WATER PERMIT NO. 1096A-1

Name of Applicant: Butte-Meade Sanitary Water District

SOUTH DAKOTA
WATER PERMIT No. 1096A-1 FOR IRRIGATION AND RURAL WATER SYSTEM

REPORT ON APPLICATION NOS. 1096A-1 AND 1496-1
FOR BUTTE MEADE SANITARY WATER DISTRICT
July 17, 1990

Map of Existing Well Location
SE $\frac{1}{4}$ - SW $\frac{1}{4}$ - Sec 20 - T9N - R3E - BHM

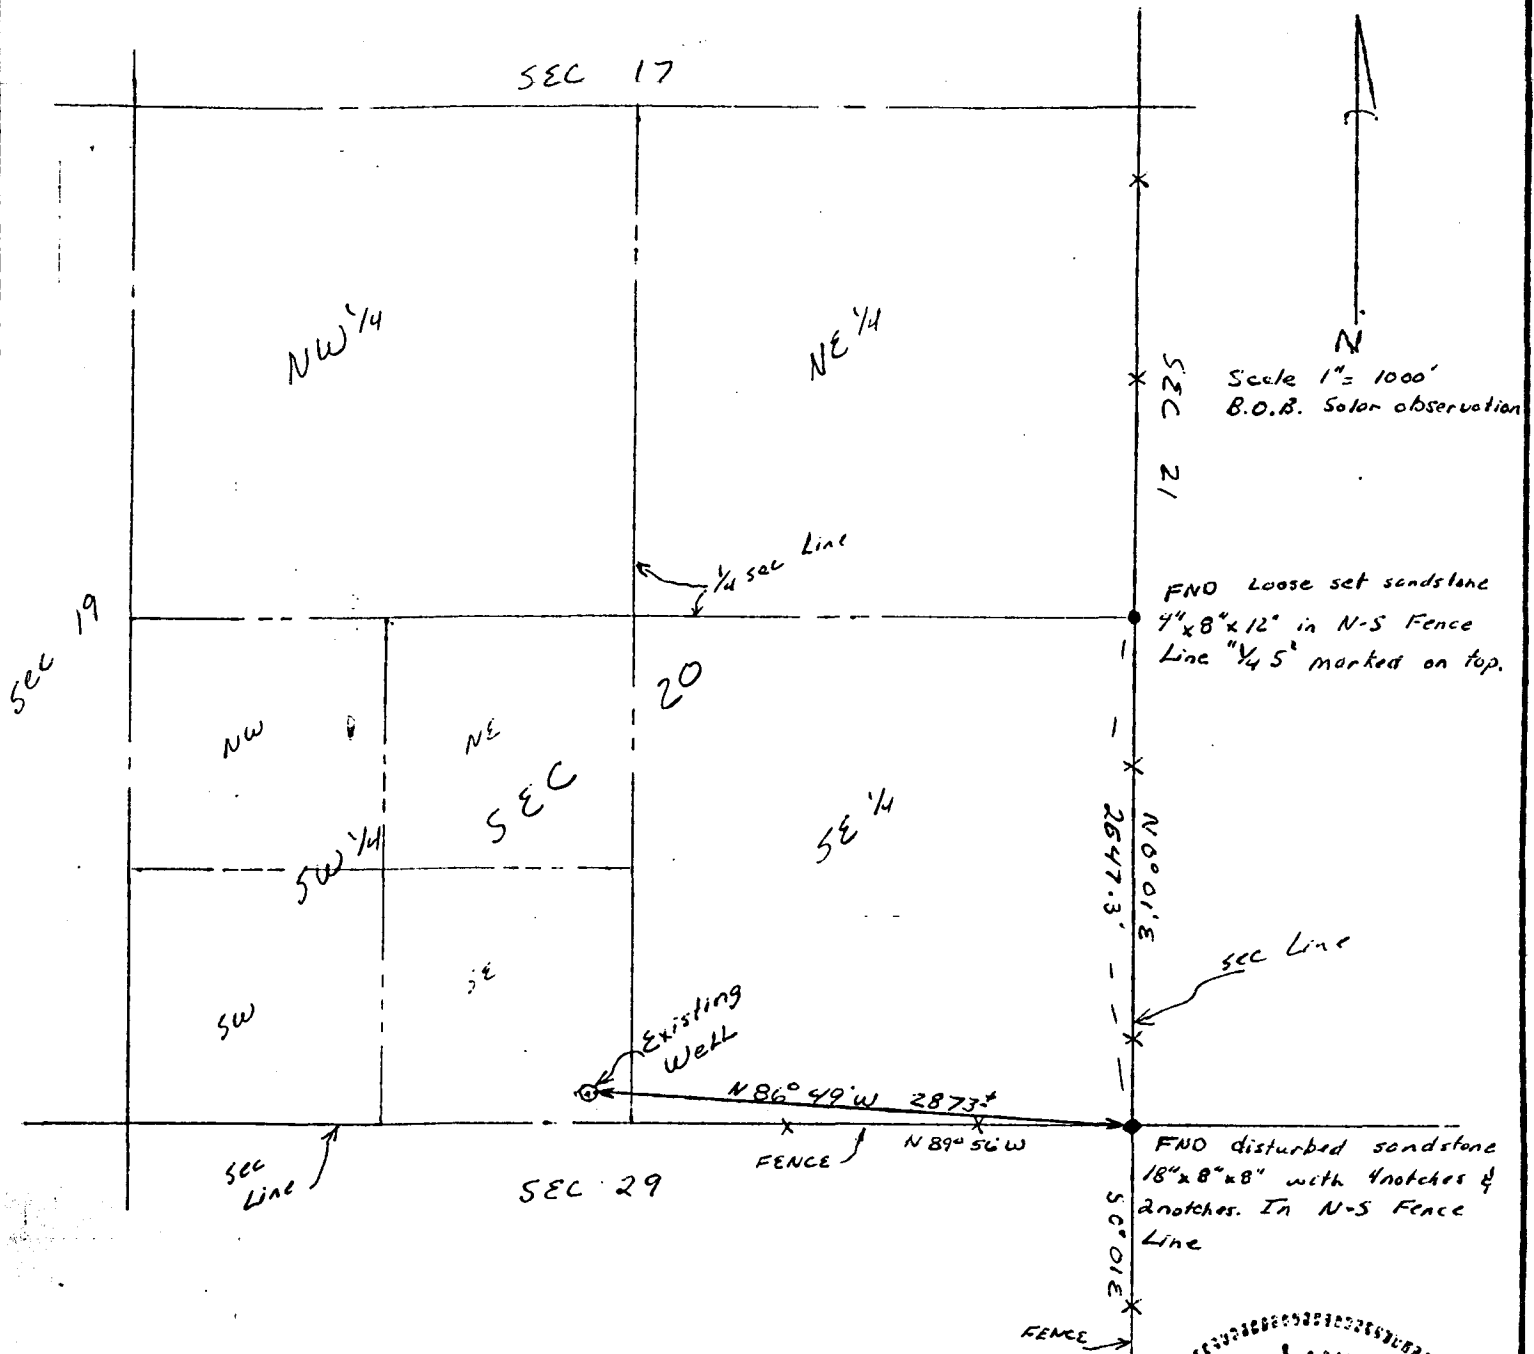
I also stated that a map was not submitted. This map must show the location of the point of diversion (well) and be signed by one of the following: 1) SD Professional Engineer; 2) SD Registered Land Surveyor; 3) a government employee who prepares maps as a normal part of their job (ASCS, SCS, etc.).

Enclosed please find Form 2A to the application for water permit of Butte-Meade Sanitary Water District. I have also enclosed a map showing the location of the point of diversion of the well. This map is signed by a South Dakota Registered Land Surveyor.
